# H2Teesside Project

The H2Teesside Order

Document Reference: 7.10 Change Notification 2 (Notification of Further Proposed Changes to the H2Teesside DCO Application and Response to CAH2-AP4)

Date: January 2025

CHANGE NOTIFICATION NO. 2 APPENDIX 1  
NATPOWER SITE  
SHEET 1 OF 3

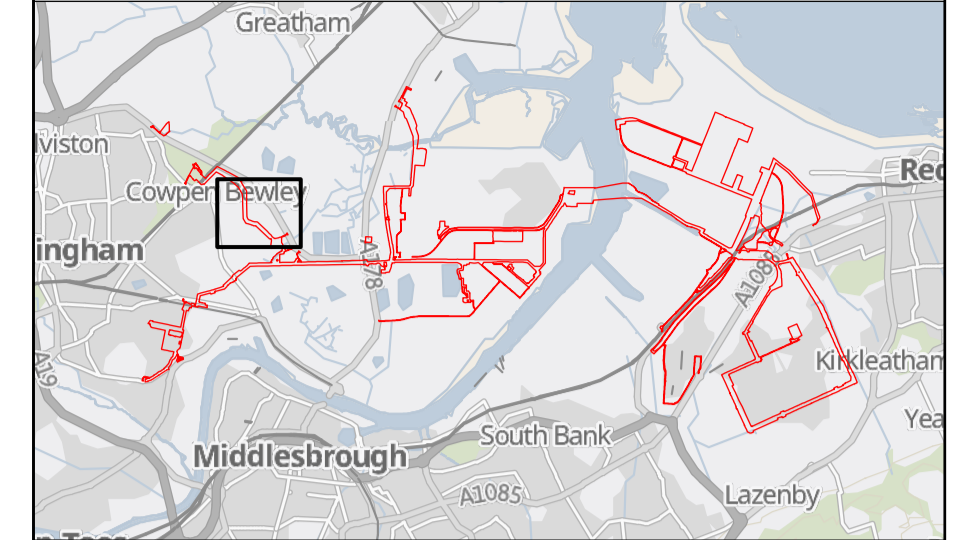
- 2.1.1 A change is proposed in this area as a result of the Examination submissions of South Tees Group ('STG'), who have brought to the Applicant's attention a planning application by NatPower UK for a Battery Energy and Storage System (BESS) project to the east of the Main Site.

- 2.1.2 Currently, the Order limits for the Proposed Development slightly overlap with the western edge of that development. Following discussions with STG and in the spirit of co-operation, the Applicant has agreed to reduce the flexibility sought in relation to the construction of its project in this area and remove the areas of overlap from the Order limits.

- 2.1.3 This change is shown at a high level on Sheet 1 of Appendix 1. The Applicant can confirm that this change will:
- necessitate a slight reduction in size of plots 15/36 and 15/166 of the Land Plans (to be also reflected in the Book of Reference);

- necessitate the removal of Work No. 6A.1 (hydrogen pipeline) on Sheets 22/23, and Work No. 8 (oxygen and nitrogen connections) on Sheet 12, from the Works Plans at these locations; but
